BID ADDENDUM NO. 2

November 12th, 2026
Corning-Painted Post ASD
2025 Erwin Valley Elem & Admin Building Alterations
2649-160

The following Addendum items shall be considered a part of the contract documents prepared by HUNT ENGINEERS, ARCHITECTS, LAND SURVEYORS & LANDSCAPE ARCHITECT, DPC. Bid Document date of October 12, 2026

4 SOCCER SCOREBOARD DETAIL

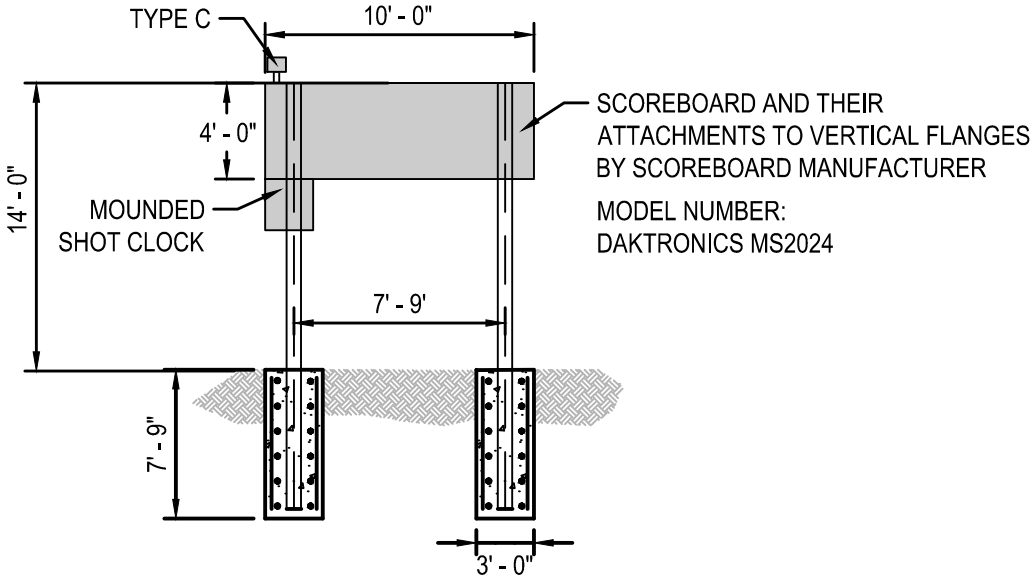
ITEM AD2-65 Refer to Drawing EV-E4.1 - SITE ELECTRICAL UTILITY PLAN

ADD Detail 1 on AD2-E3 - ADDITIONAL ELECTRICAL SITE DETAILS, as issued in this addendum to EV-E4.1 - SITE ELECTRICAL UTILITY PLAN.

1 FIRST FLOOR POWER PLAN - STAGE POWER PLAN

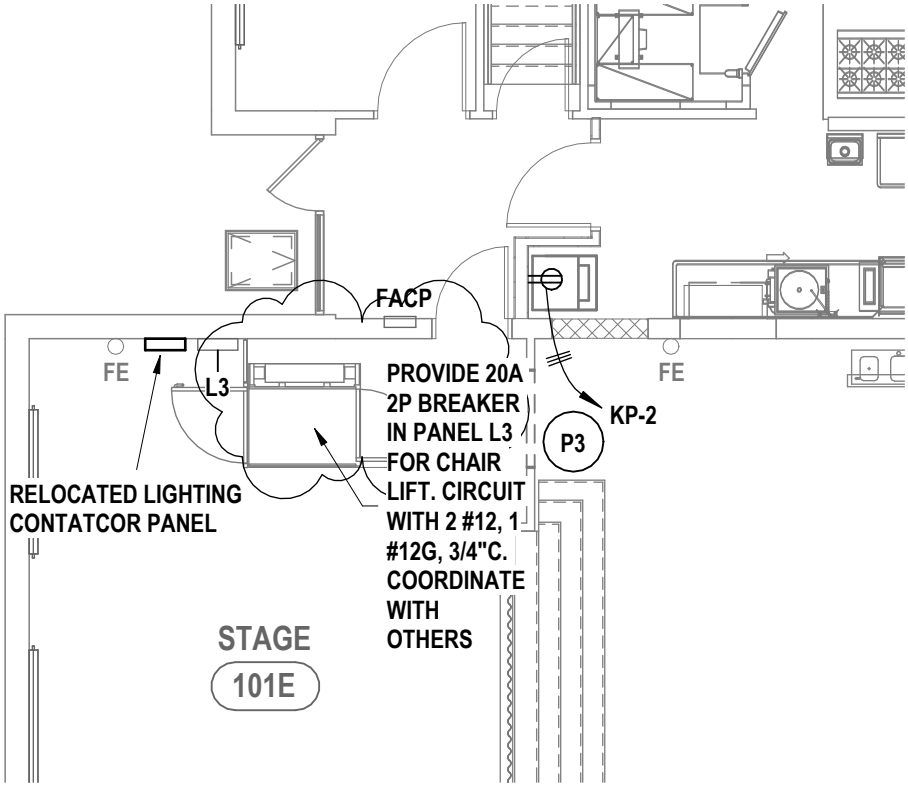
ITEM AD2-61 Refer to Drawing EV-E1.2 - FIRST FLOOR POWER PLAN - AREA B
AMEND Detail 1 with AD2-E4 - PARTIAL STAGE POWER PLAN, as issued in this addendum.

1 FIRST FLOOR ELECTRICAL DEMOLITION PLAN - KITCHEN
1/8" = 1'-0"

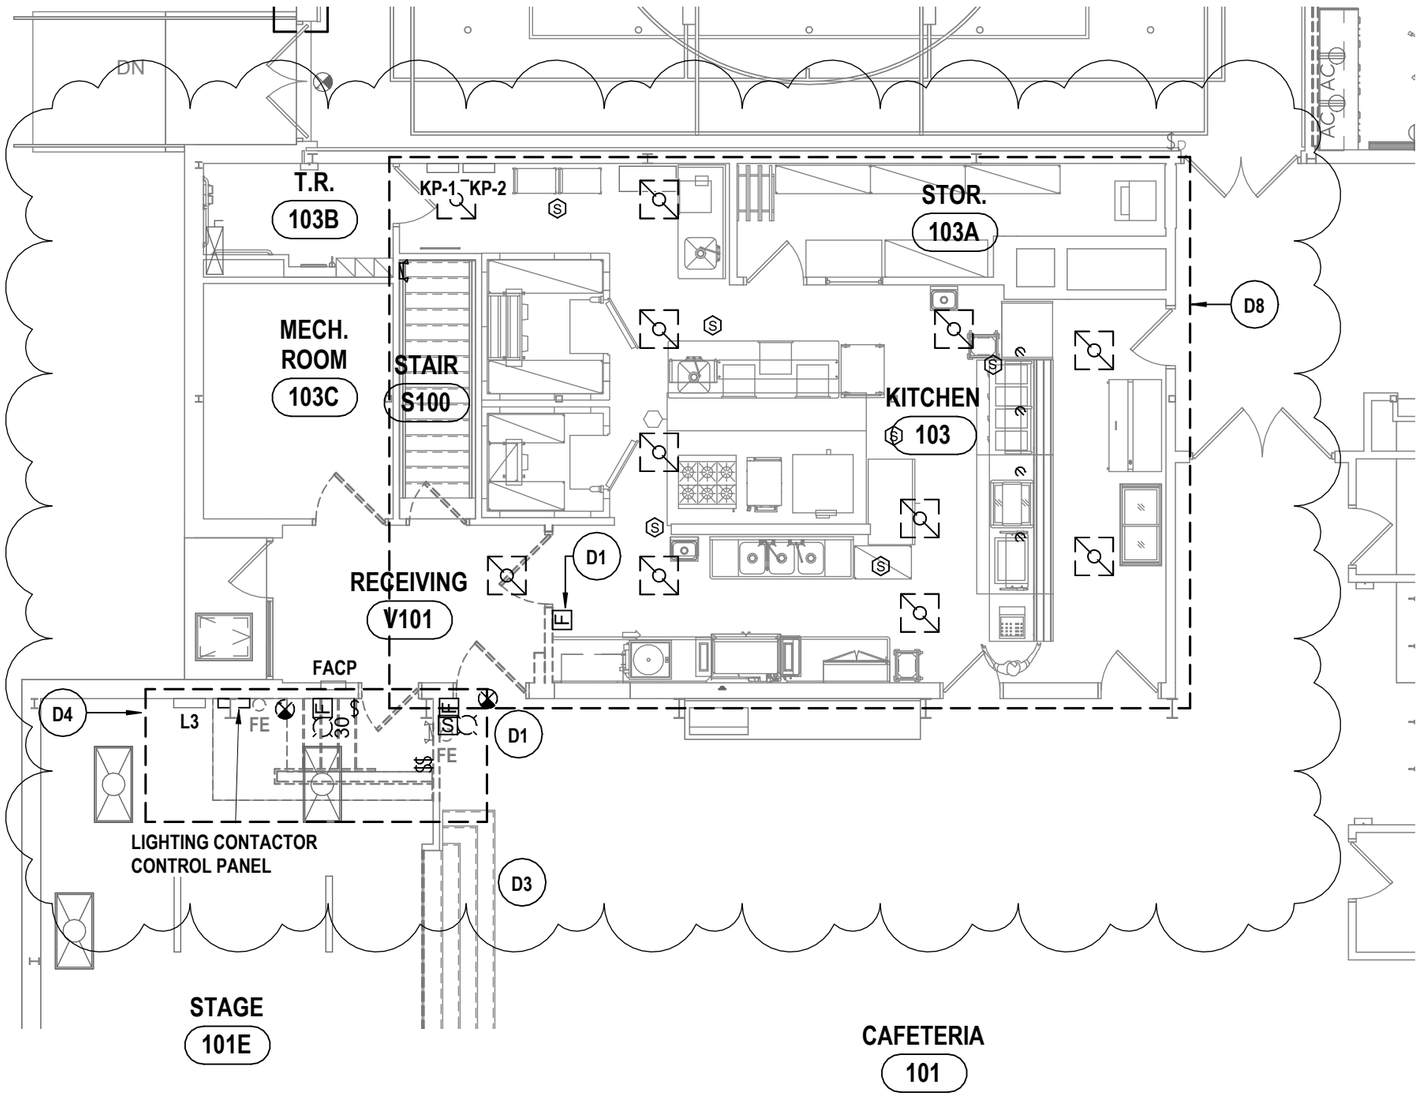
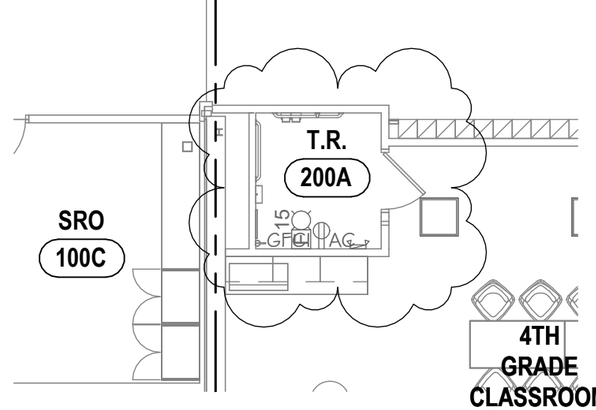
ITEM AD2-59 Refer to Drawing EV-E0.2 - FIRST FLOOR DEMOLITION PLAN - AREA B
AMEND Detail 1 with AD2-E5 - PARTIAL FIRST FLOOR DEMOLITION PLAN, as issued in this addendum.

1 **FIRST FLOOR ELECTRICAL DEMOLITION PLAN - GYM**
1/8" = 1'-0"

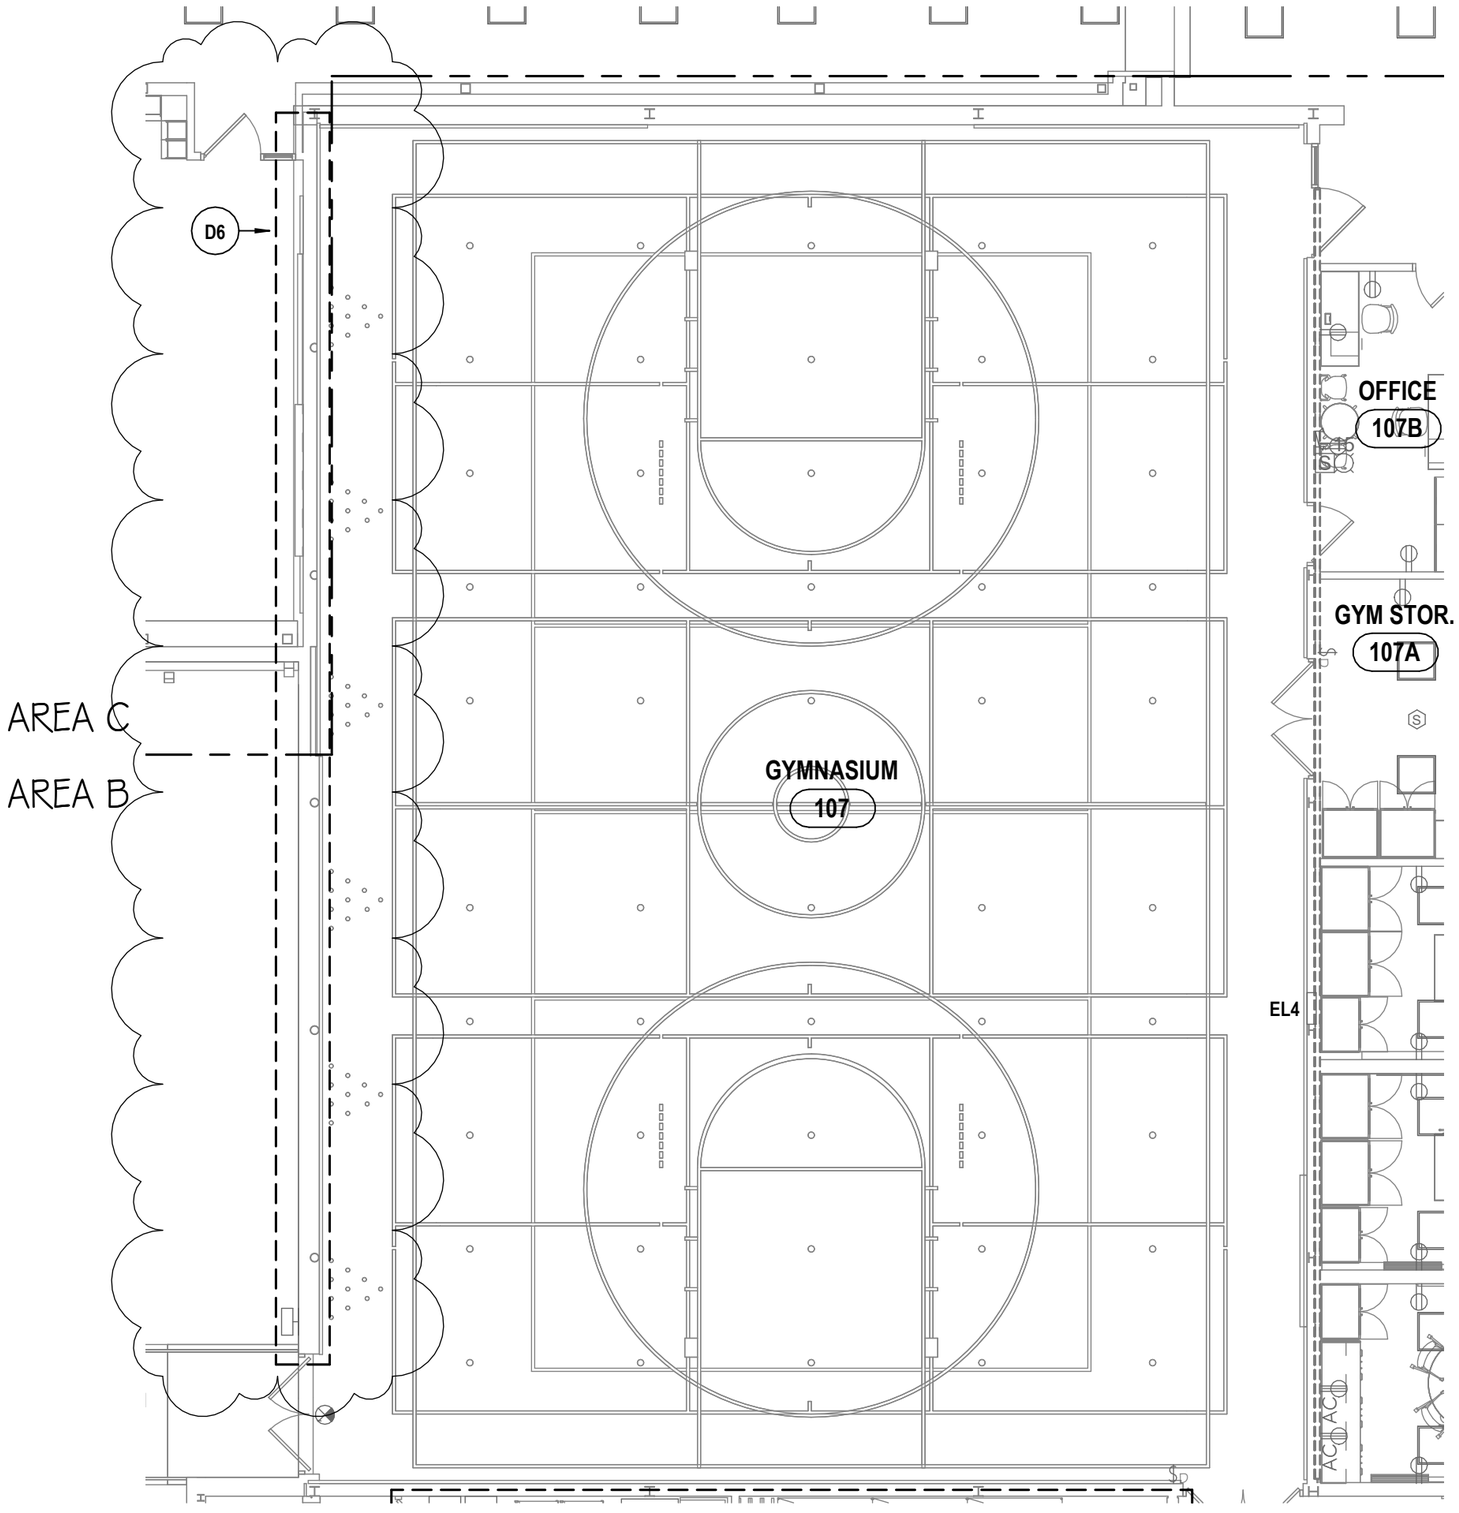
ITEM AD2-60 Refer to Drawing EV-E0.2 - FIRST FLOOR DEMOLITION PLAN - AREA B
AMEND Detail 1 with AD2-E6 - PARTIAL FIRST FLOOR DEMOLITION PLAN, as issued in this addendum.

ONE LINE REVISIONS

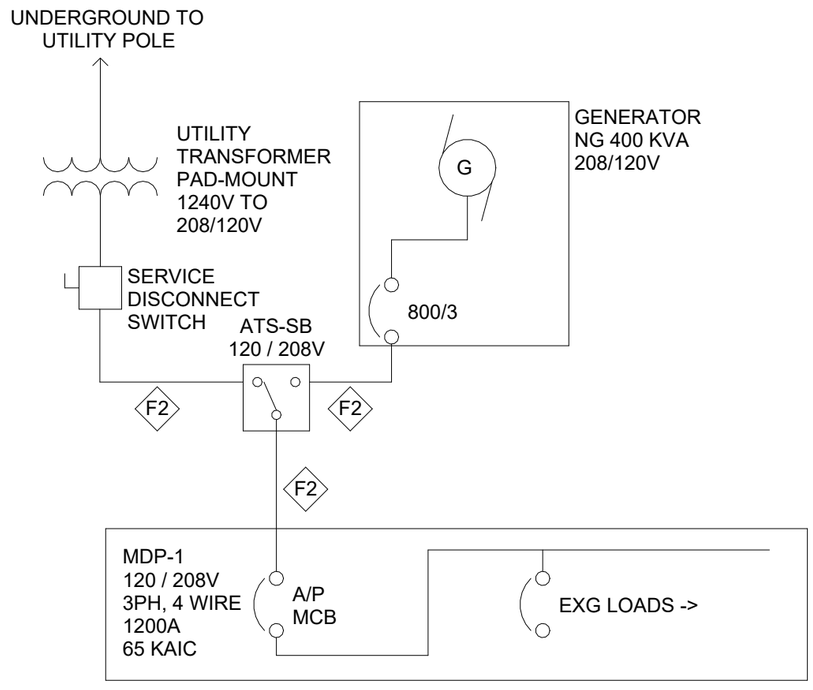
ITEM AD2-67 Refer to Drawing EV-E5.1 - SCHEDULES & DETAILS

AMEND "One Line Diagram" with AD2-E8 - ONE LINE REVISIONS, as issued in this addendum.
